Gachsaran Polymer Industries Company HDPE Plant		
	LCP and Junction Box Layout, Arrangement and Wiring Drawing for Refrigerator Package		 
PO No.: GPIC-PT-MA-PO-000-3029	Document Number: VD-GPIC-MA-3029-3029-0046	Rev. 00	Page 1 of 14

LCP and Junction Box Layout, Arrangement and Wiring Drawing for Refrigerator Package

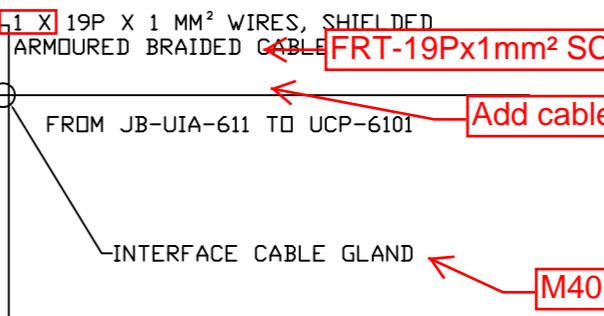
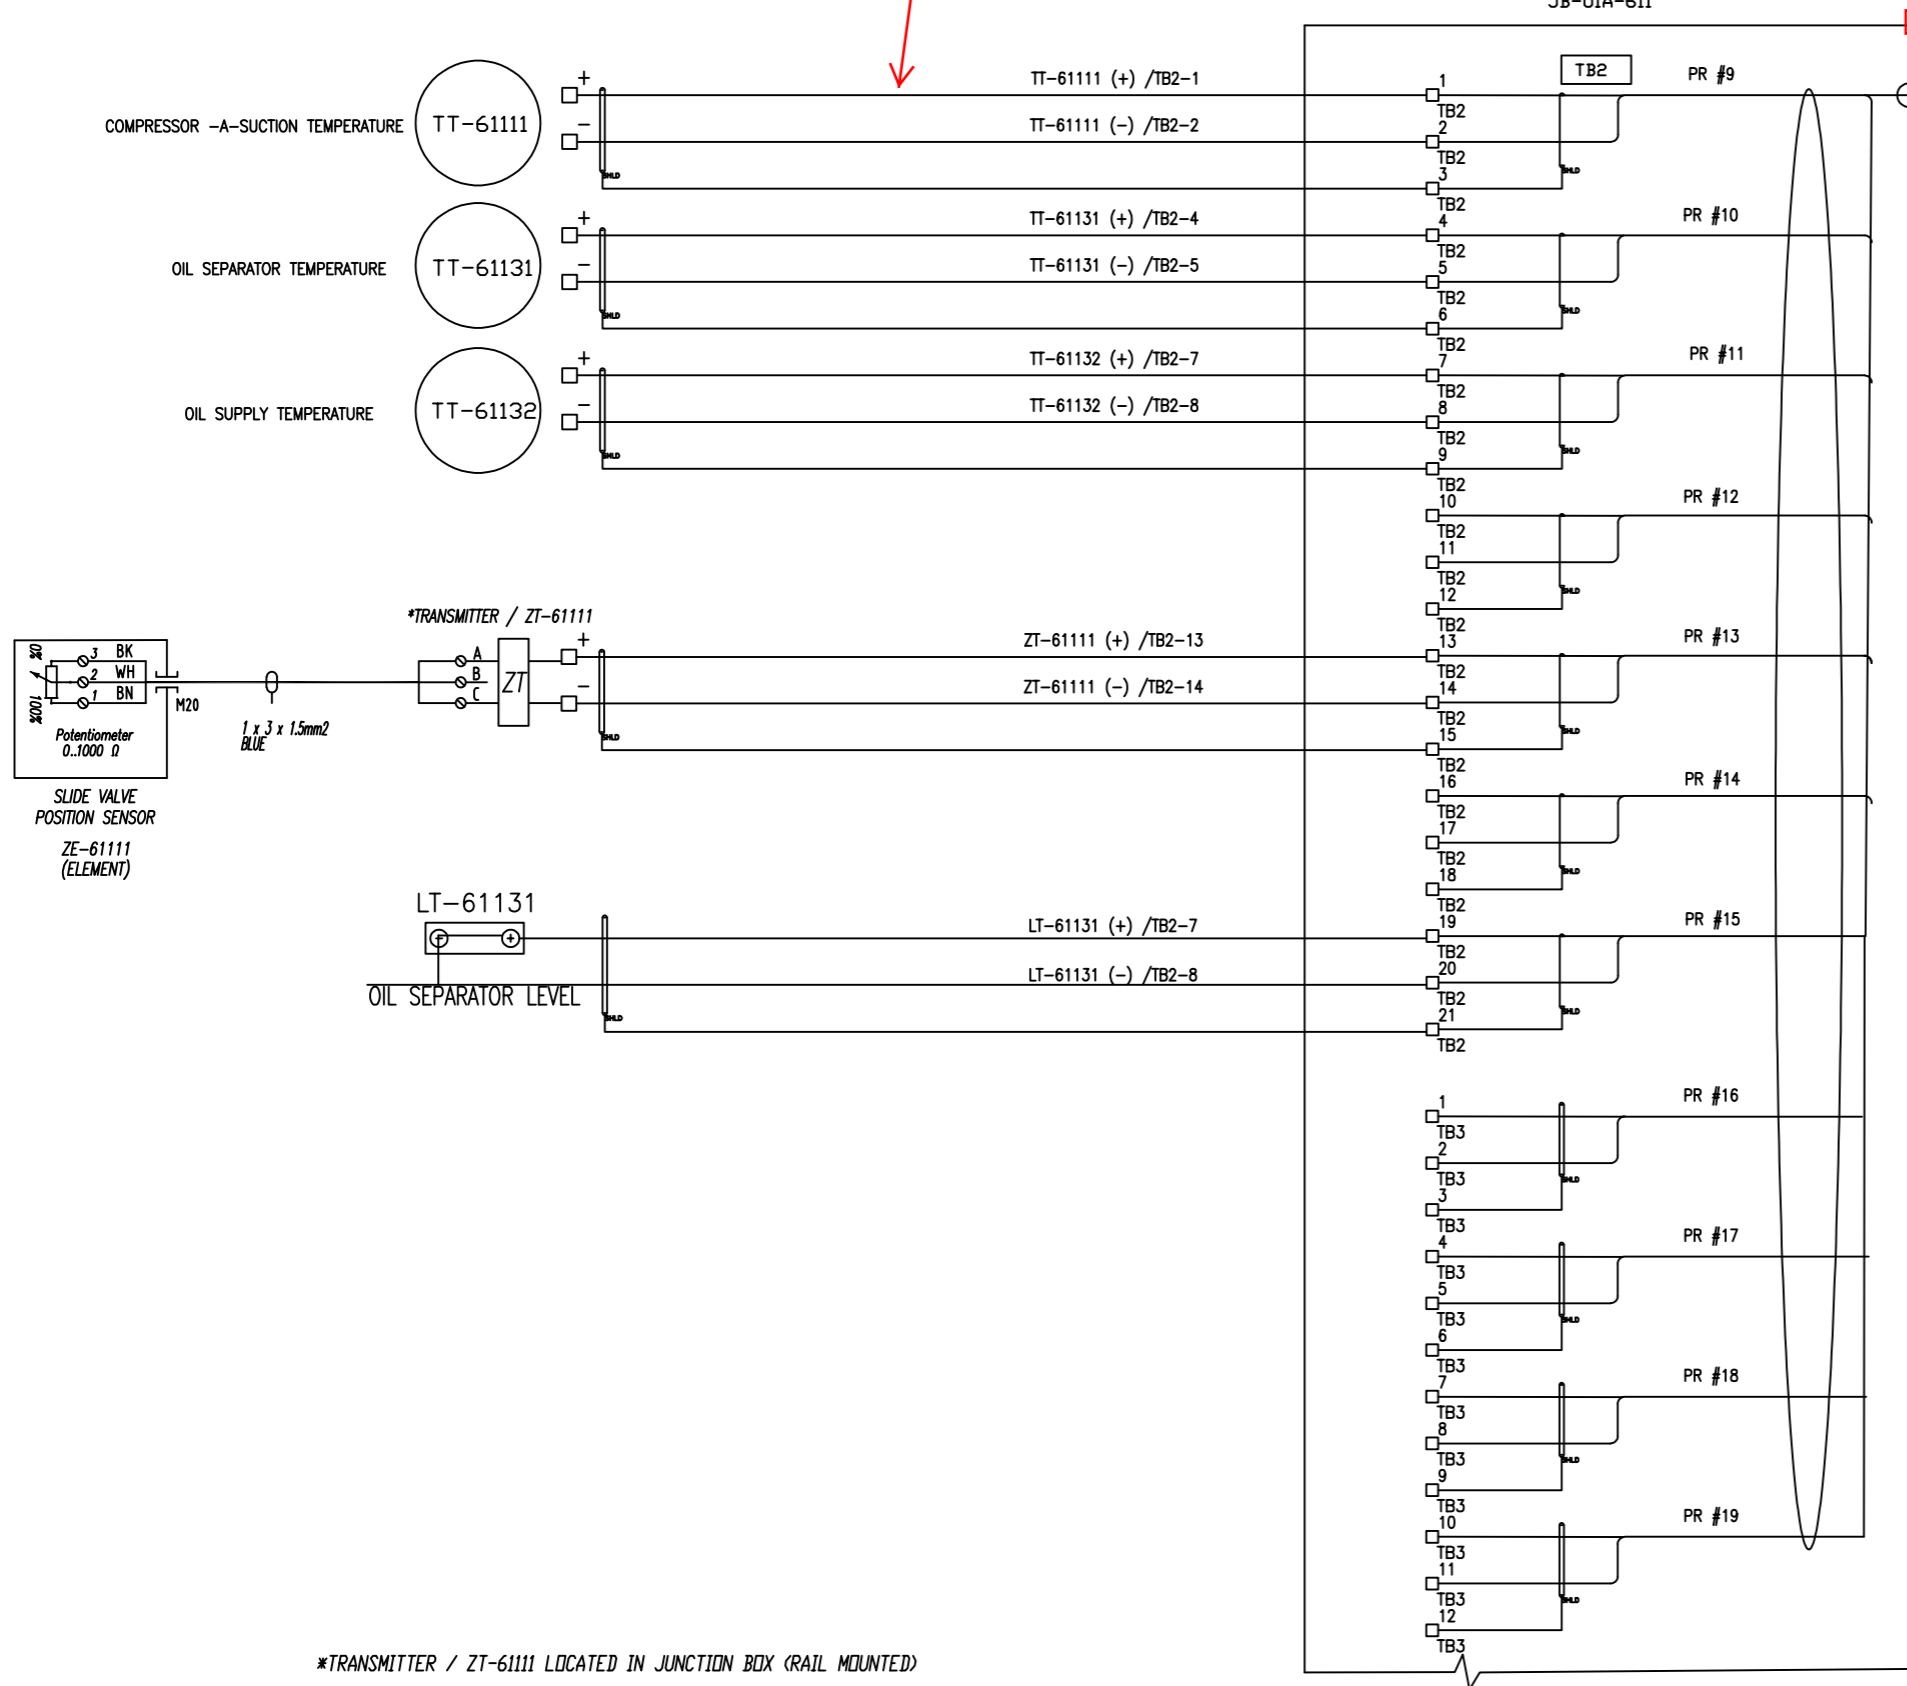
"FRT-01Px1.5mm² OSCR/SWA/IS/BLUE (300/500)"
for all single pair cables.

Delete it.

Add cable tag: IC-UIA-611

Tag number of digital JB shall be UID.
 Separated JB for digital signals shall be considered.
 It is not acceptable that 2 multi-pair cables are connected to one JB.

FRT-19Px1mm² SCR/OSCR/SWA/IS/BLUE (300/500)

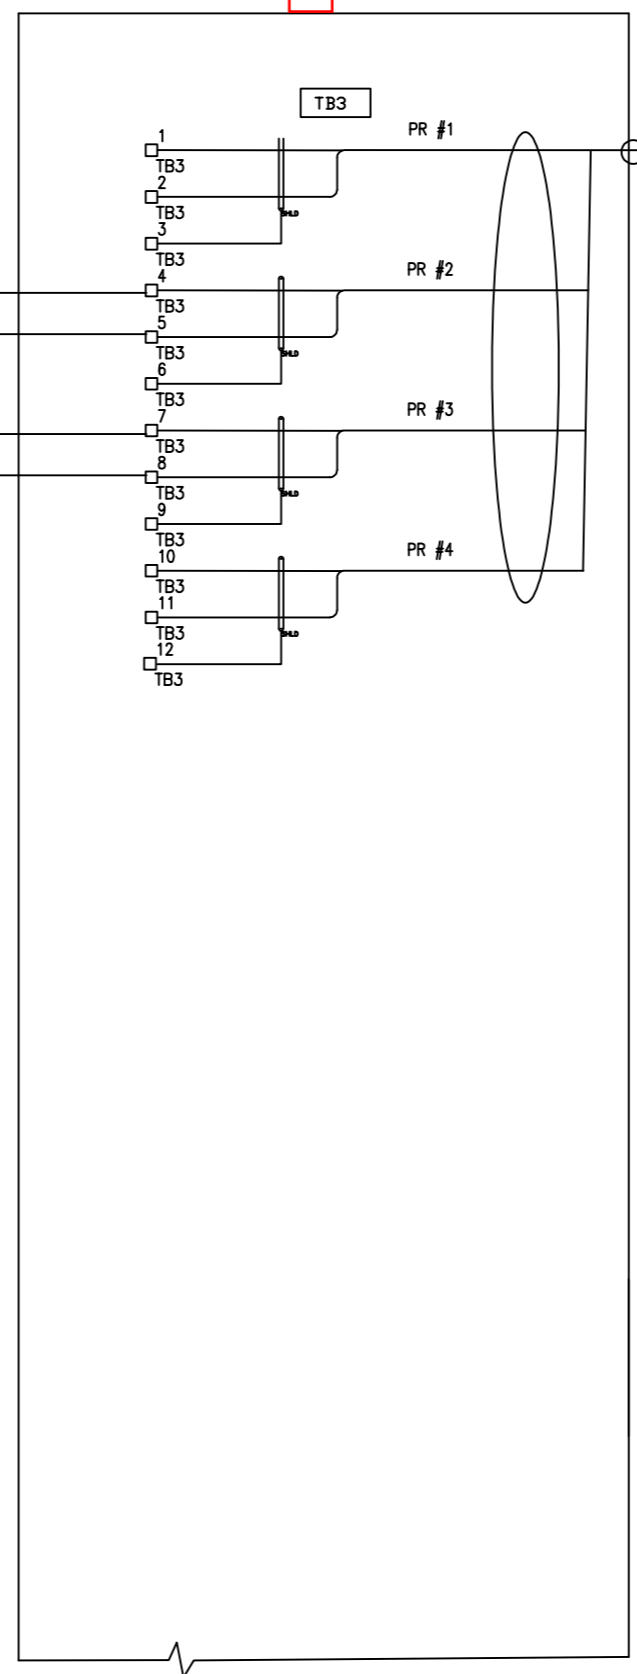
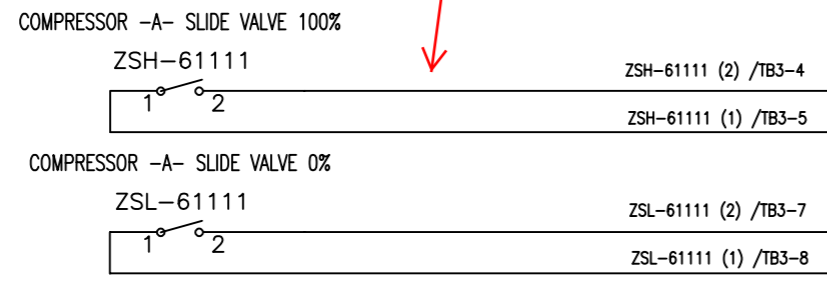
"FRT-01Px1.5mm² OSCR/SWA/IS/BLUE (300/500)"
 for all single pair cables.

Delete it.

Add cable tag: IC-UID-611

1 X 4P X 1 MM² WIRES, SHIELDED
 ARMoured BRAIDED CABLE FRT-04Px1mm² OSCR/SWA/IS/BLUE (300/500)
 FROM JB-UIA-611 TO UCP-6101

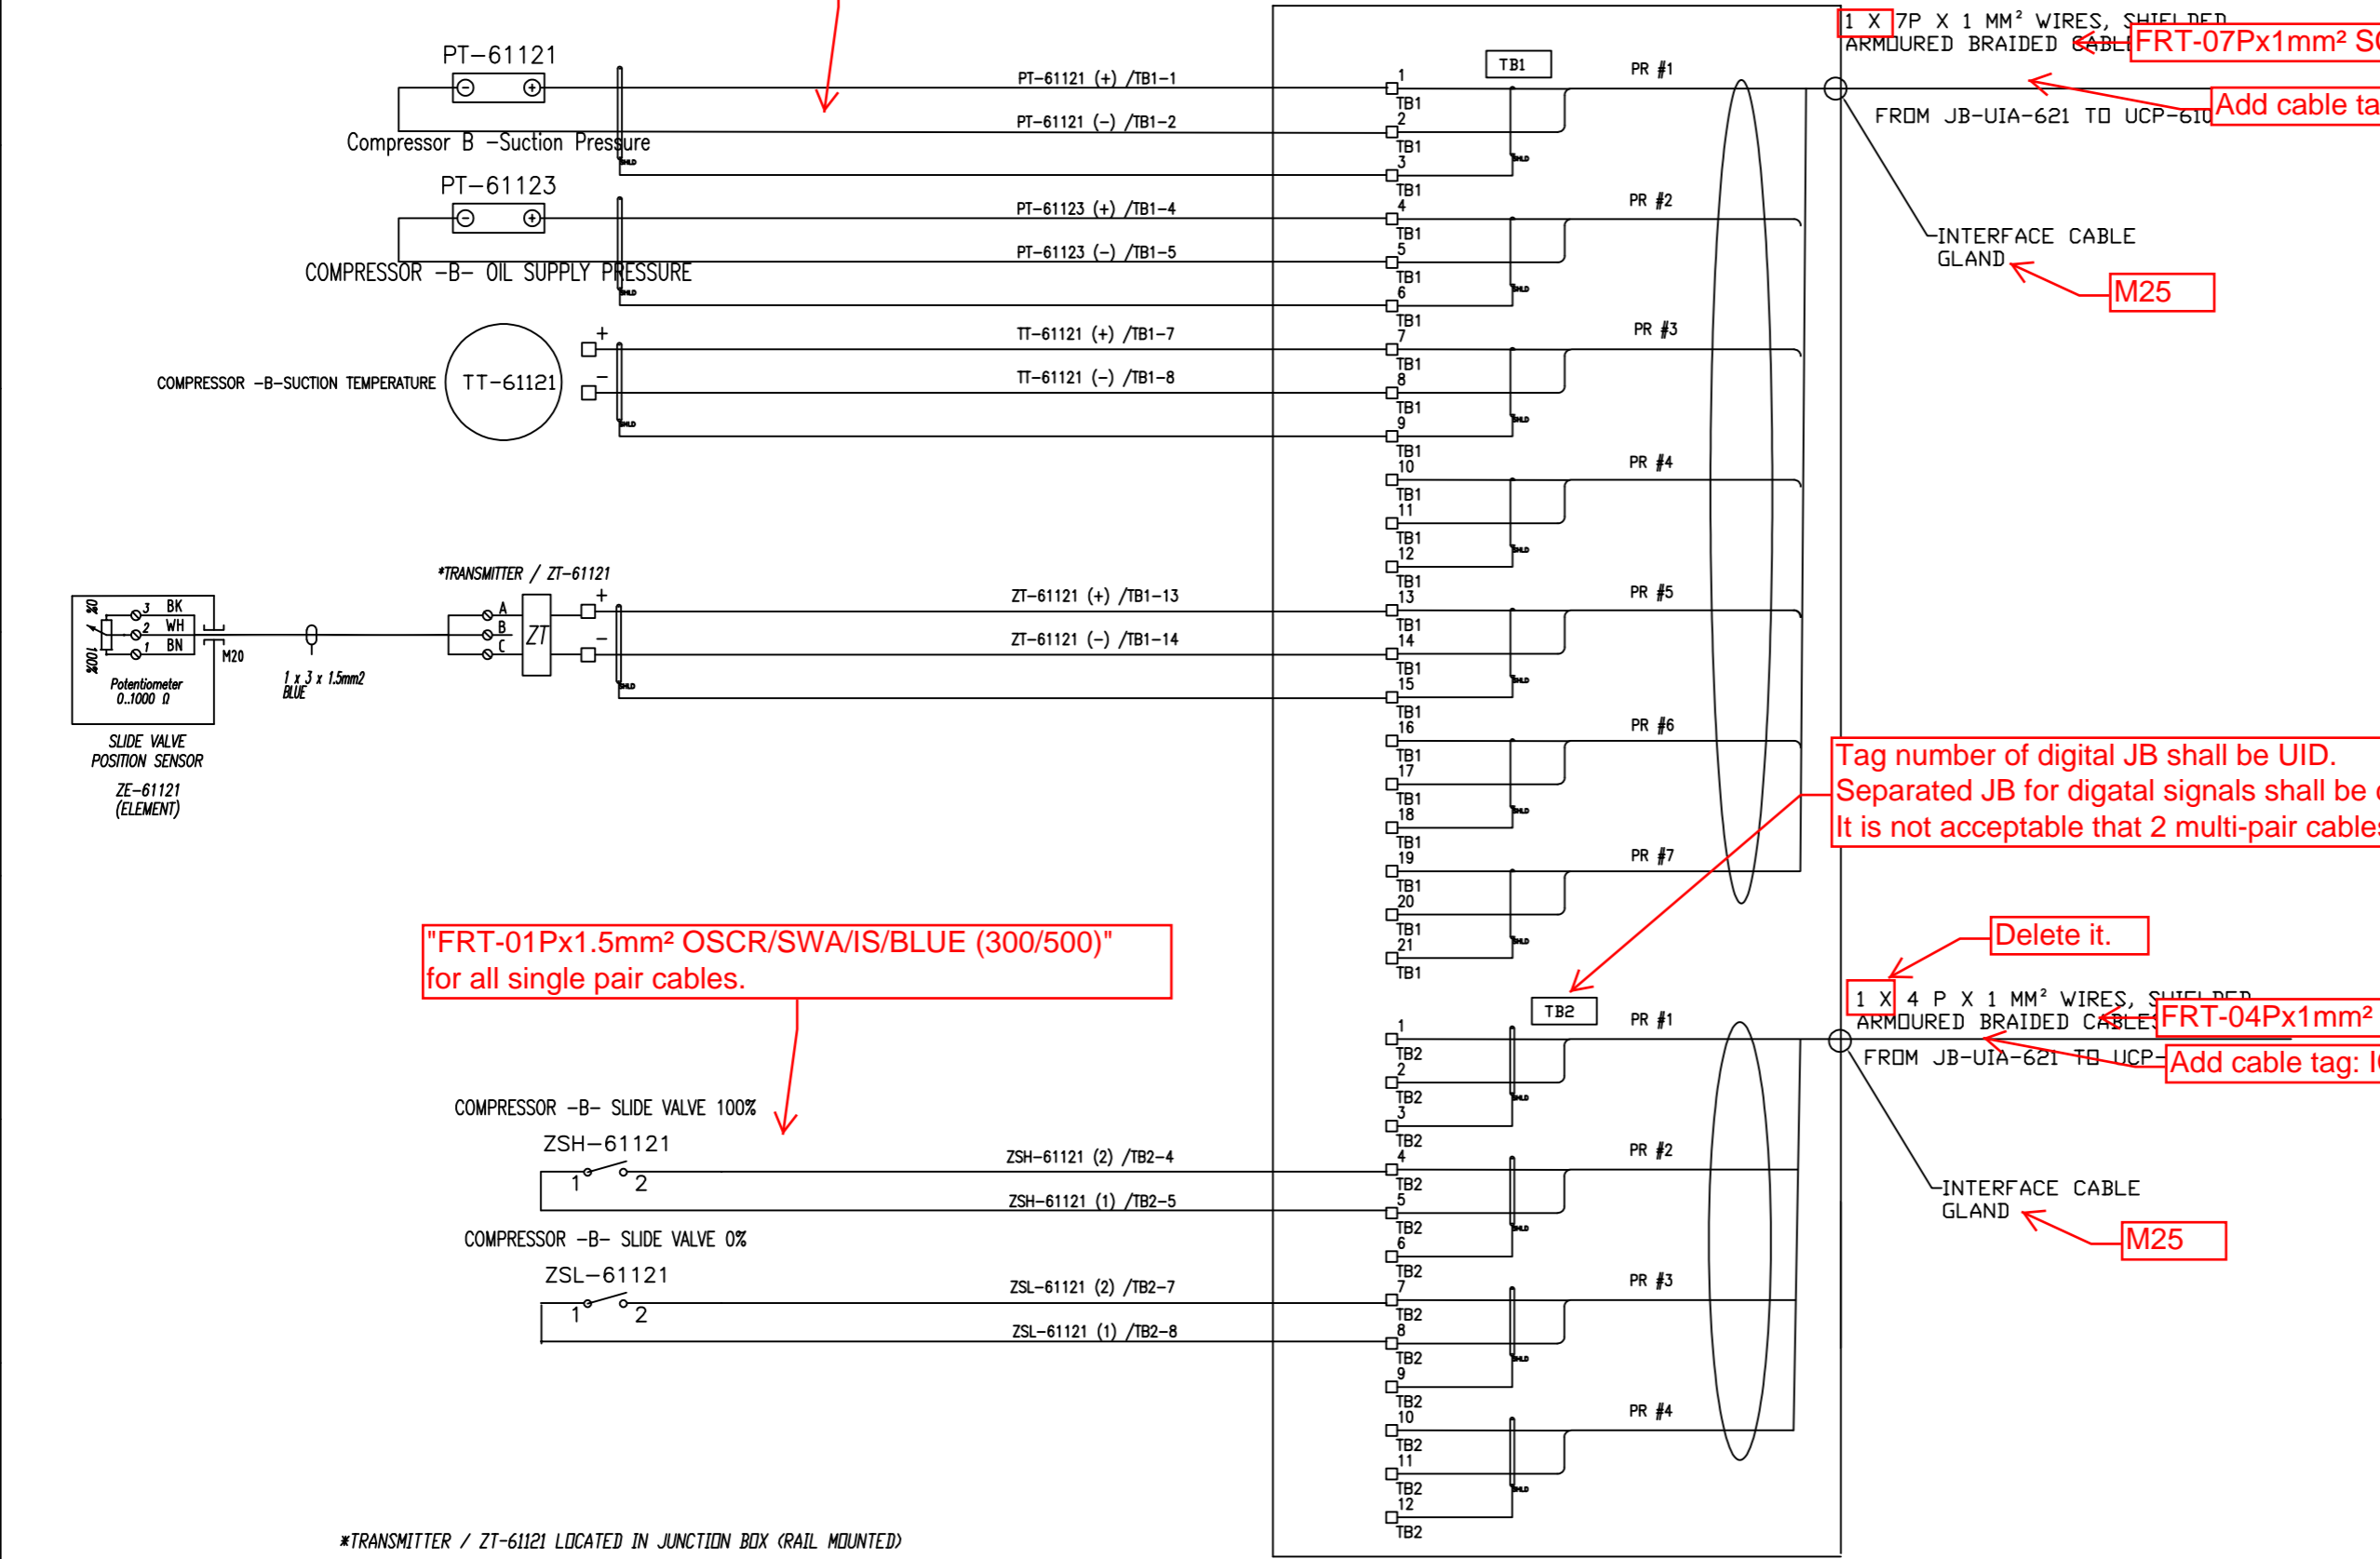
"FRT-01Px1.5mm² OSCR/SWA/IS/BLUE (300/500)"
for all single pair cables.

Delete it.

Add cable tag: IC-UIA-621

Tag number of digital JB shall be UID.
Separated JB for digital signals shall be considered.
It is not acceptable that 2 multi-pair cables are connected to one JB.

Delete it.

Add cable tag: IC-UID-621

"FRT-01Px1.5mm² OSCR/SWA/IS/BLUE (300/500)"
for all single pair cables.

1 X 7P X 1 MM² WIRES, SHIELDED
ARMORED BRAIDED CABLE FROM JB-UIA-621 TO UCP-610
"FRT-07Px1mm² SCR/OSCR/SWA/IS/BLUE (300/500)"
Add cable tag: IC-UIA-621

1 X 4 P X 1 MM² WIRES, SHIELDED
ARMORED BRAIDED CABLE FROM JB-UIA-621 TO UCP-610
"FRT-04Px1mm² OSCR/SWA/IS/BLUE (300/500)"
Add cable tag: IC-UID-621

JB-UEV-612

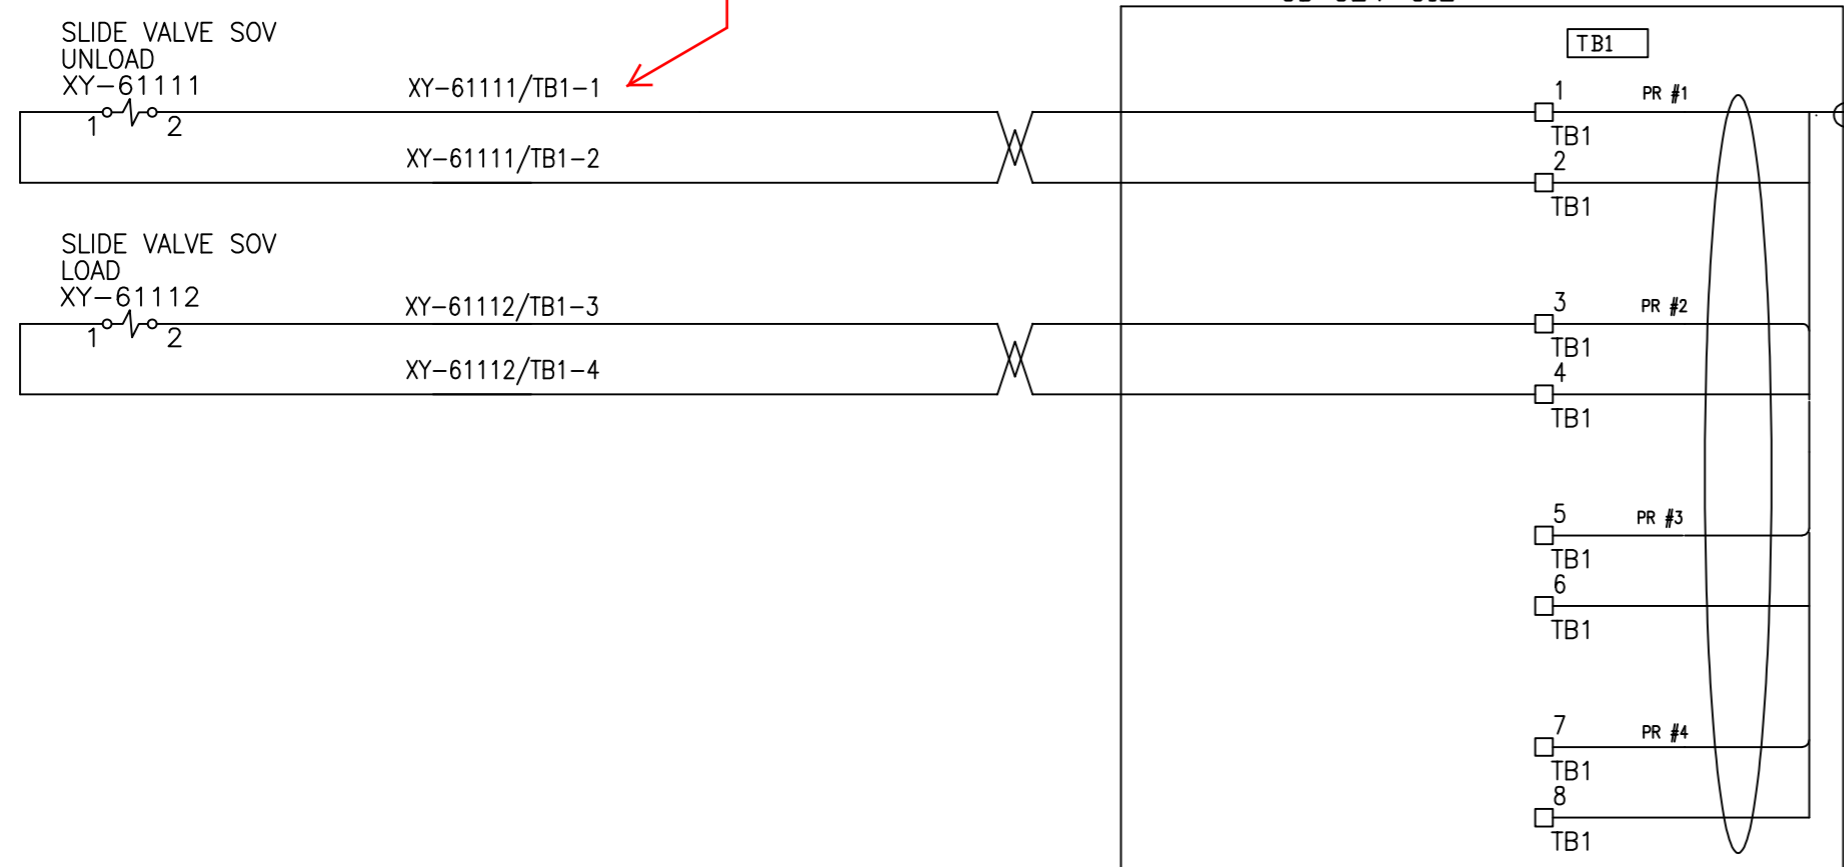
"FRT-01Px2.5mm² SWA/NIS/GRAY (300/500)"
for all single pair cables.

Delete it.

Add cable tag: IC-UEV-612

1 X 4P X 2.5 MM² WIRES, SHIELDED
ARMORED BRAIDED CABLES - FRT-04Px2.5mm² SWA/NIS/GRAY (300/500)
